From: [REDACTED]
Sent: 13 December 2018 12:06
To: Planning.Responses
Subject: planning application consultation -Y/81/18/HH

Your Ref
Y/81/18/HH
Our Ref
PLAN-025520
Date
13/12/2018

Proposal: Loft conversion involving addition of dormer. This application affects the setting of a Listed Building.
Site: 1 Church Farm Cottages, Church Road, Yapton, BN18 0EP.
Y/81/18/HH

Southern Water MapGuide Browser

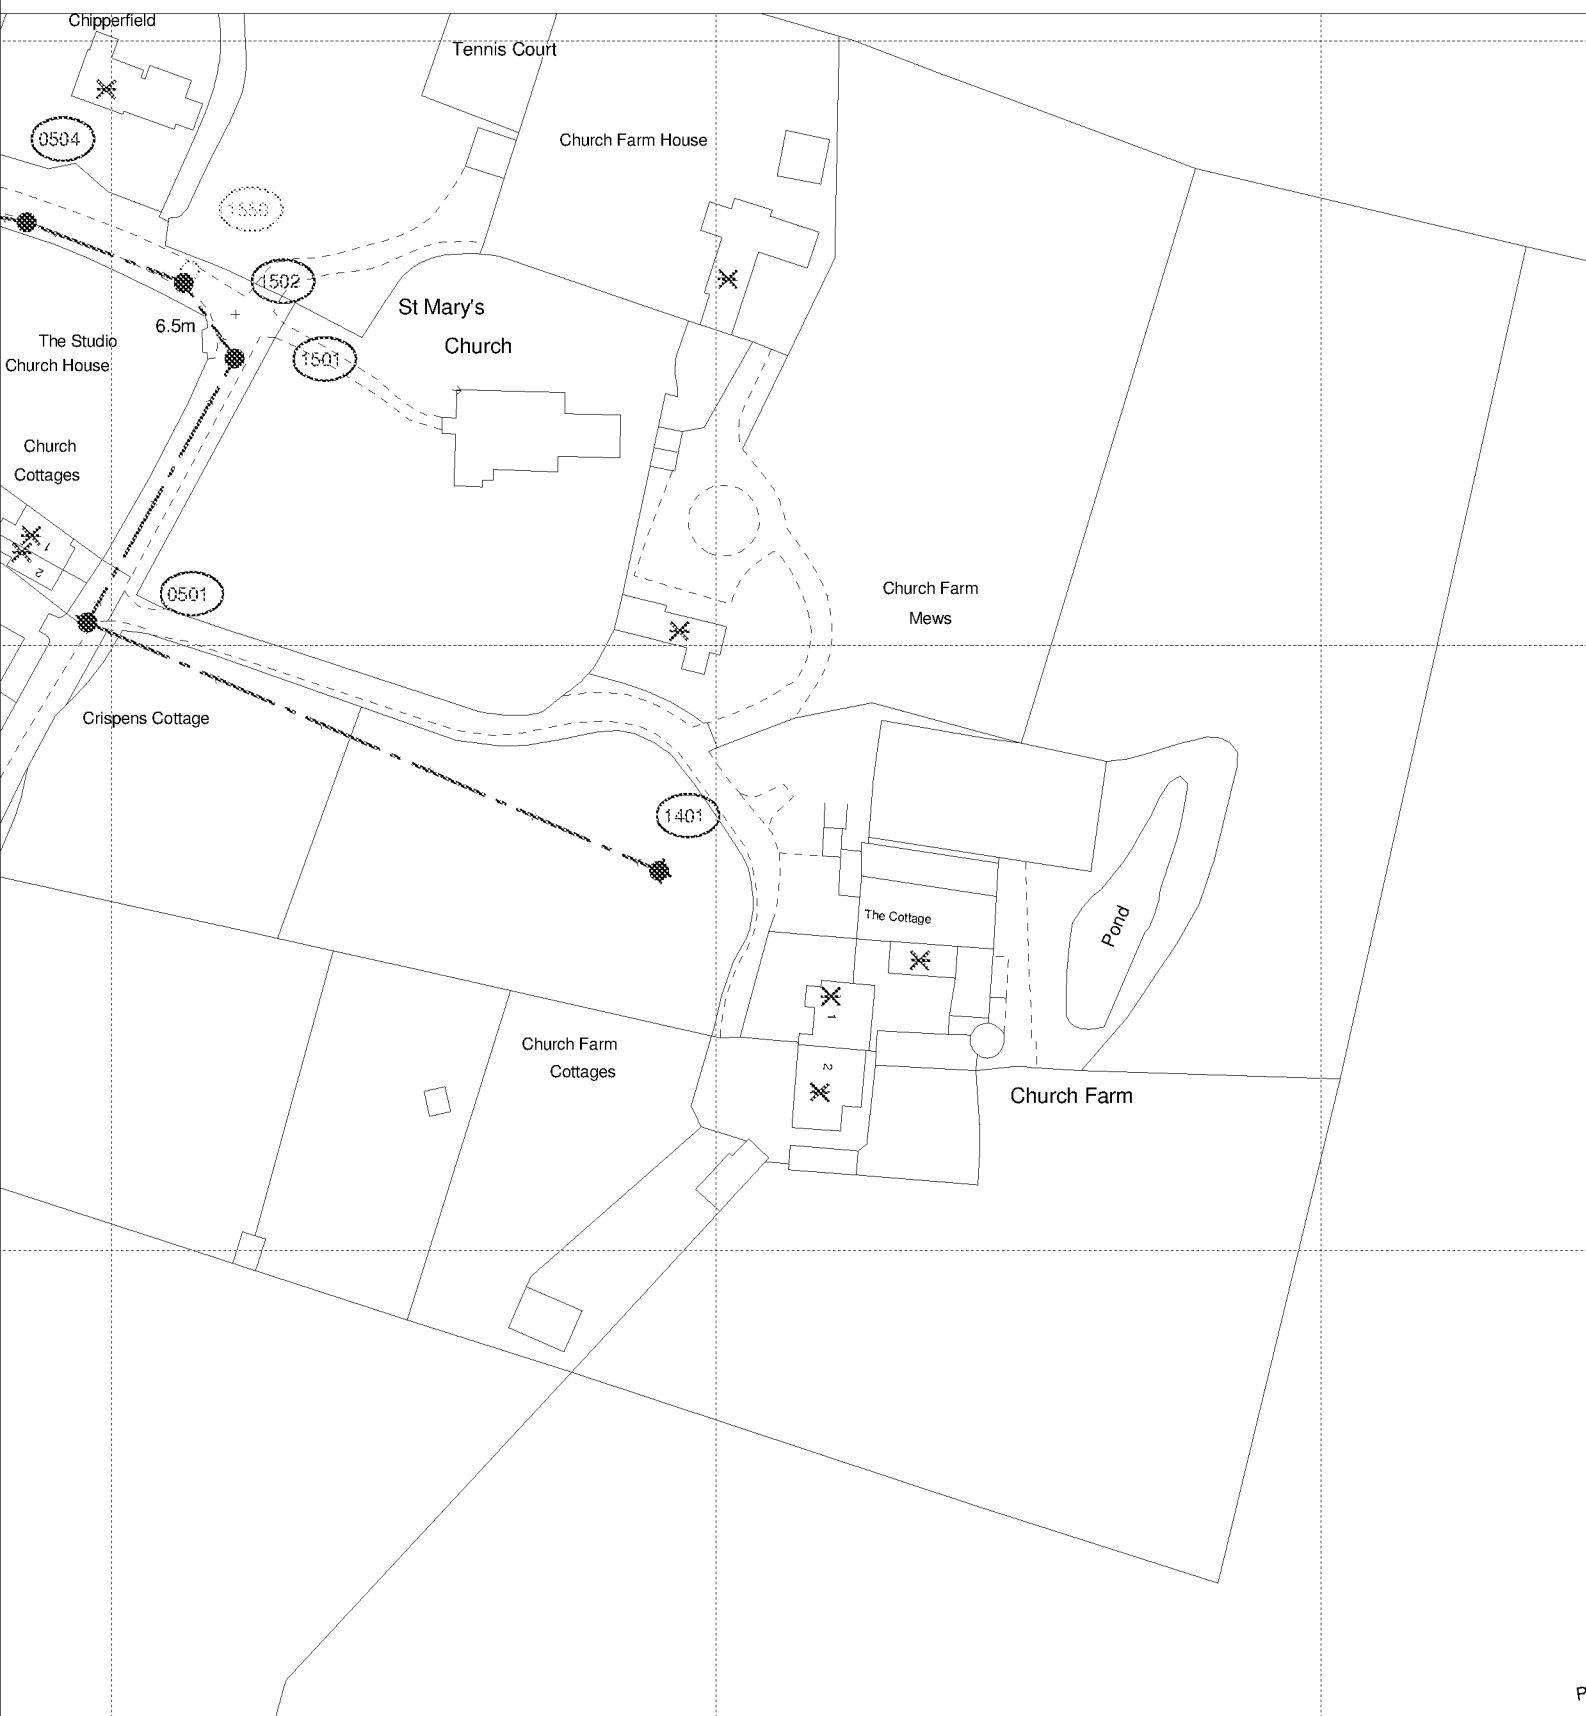
Our initial investigations indicate that there are no public surface water sewers in the area to serve this development. Alternative means of draining surface water from this development are required. This should not involve disposal to a public foul sewer.

Due to changes in legislation that came in to force on 1st October 2011 regarding the future ownership of sewers, it is possible that a sewer now deemed to be public could

be crossing the above property. Therefore, should any sewer be found during construction works, an investigation of the sewer will be required to ascertain its condition, the number of properties served, and potential means of access before any further works commence on site.

Developer should look to protect the public sewerage system from inundation and infiltration, which contribute to flooding in unfavourable conditions.

The applicant is advised to discuss the matter further with Southern Water, Sparrowgrove House, Sparrowgrove, Otterbourne, Hampshire SO21 2SW ([REDACTED] or www.southernwater.co.uk).
